June 28, 2017
L-2017-100
10 CFR 50.90

RE: Turkey Point Nuclear Plant, Units 3 and 4
Docket Nos. 50-250 and 50-251
Renewed Facility Operating Licenses DRR-31 and DPR-41

License Amendment Request (LAR) 248, Changes to Technical Specifications Regarding
Inservice Testing Program and Inservice Inspection Program Requirements and Surveillance
Frequency Control Program Applicability

Turkey Point Units 3 and 4
License Amendment Request (LAR) No. 248
Changes to Technical Specifications Regarding
Inservice Testing Program and Inservice Inspection Program
Requirements and Surveillance Frequency Control Program Applicability

Figure 3.5-1
~~RHR Pump Curve~~

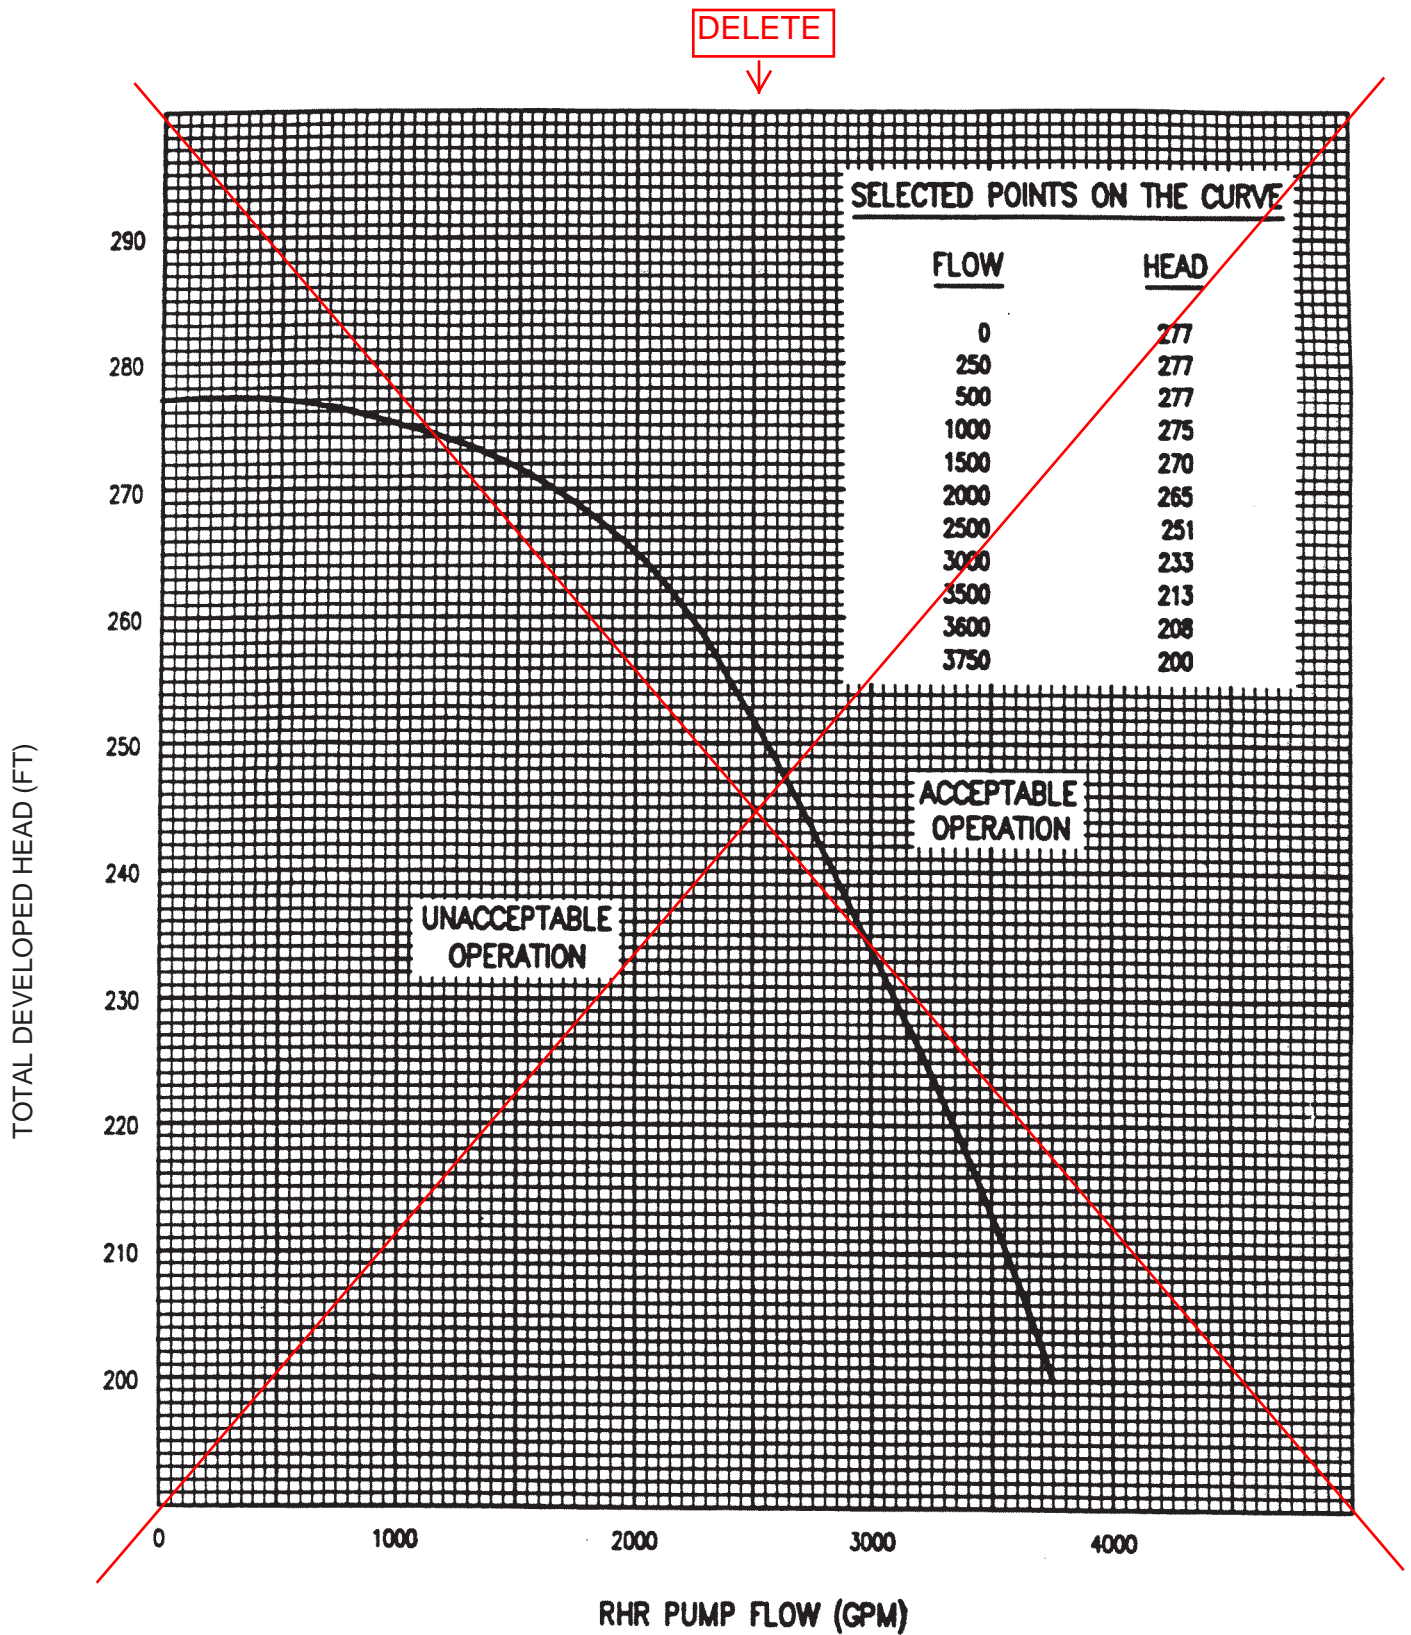
SR 4.5.2.c, Figure 3.5-1, Residual Heat Removal (RHR) Pump Curve, and SR 4.6.2.1.b specify acceptance criteria related to design parameters for Safety Injection (SI), RHR and Containment Spray (CS) pump inservice testing. The proposed change relocates the acceptance criteria specified in SR 4.5.2.c, Figure 3.5-1 and SR 4.6.2.1.b for the SI, RHR and CS pumps, to IST Program procedures by deleting Figure 3.5-1 and replacing the acceptance criteria in SR 4.5.2.c and SR 4.6.2.1.b with statements that each pumps' developed head at the test flow point shall be greater than or equal to the required developed head when tested in accordance with the INSERVICE TESTING PROGRAM.

The proposed change relocates the acceptance criteria specified in SR 4.5.2.c, Figure 3.5-1 and SR 4.6.2.1.b for the SI, RHR and CS pumps, to IST Program procedures by deleting Figure 3.5-1 and replacing the acceptance criteria in SR 4.5.2.c and SR 4.6.2.1.b with statements that each pumps' developed head at the test flow point shall be greater than or equal to the required developed head when tested in accordance with the INSERVICE TESTING PROGRAM.

SR 4.5.2.c.2 specifies that the RHR pumps' indicated Δp applicable to the operating conditions fall within the Acceptable Range of the RHR pump curve specified in Figure 3.5-1. Consistent with SR 3.5.2.4 of NUREG-1431 (Reference 6.2), the proposed change deletes the RHR pump curve in Figure 3.5-1 and replaces the reference to the pump curve in SR 4.5.2.c.2 with a statement that each RHR pumps' developed head at the test flow point shall be greater than or equal to the required developed head when tested in accordance with the INSERVICE TESTING PROGRAM. RHR pump acceptance criteria account for available margin for the test to assure that the design basis minimums are met. These acceptance criteria are incorporated in the IST Program and procedures. To ensure that pump performance does not degrade below that assumed in plant safety analyses, IST Program procedures specify the minimum allowable Δp as the more restrictive of the required, i.e. design basis minimum, Δp and the minimum Δp allowed by ASME OM Code. The deletion of Figure 3.5-1 from the TS neither changes the methodology in which RHR pump test acceptance criteria are established nor the manner in which the test results are evaluated. Moreover, any future changes to RHR pump inservice testing requirements will be subject to the provisions of 10 CFR 50.59 and/or 10 CFR 50.55(a)(f), as appropriate. Hence, removing Figure 3.5-1 and replacing its reference in SR 4.5.2.c.2 with a statement that each RHR pumps' developed head at the test flow point shall be greater than or equal to the required developed head when tested in accordance with the INSERVICE TESTING PROGRAM is reasonable.

- ~~1) SI pump ≥ 1083 psid at a metered flowrate ≥ 300 gpm (normal alignment or Unit 4 SI pumps aligned to Unit 3 RWST), or~~
 ~~≥ 1113 psid at a metered flowrate ≥ 280 gpm (Unit 3 SI pumps aligned to Unit 4 RWST).~~
- ~~2) RHR pump Develops the indicated differential pressure applicable to the operating conditions in accordance with Figure 3.5-1.~~

- c. By verifying that each SI and RHR pump develops the indicated differential pressure applicable to the operating conditions when tested in accordance with the INSERVICE TESTING PROGRAM.

DELETED
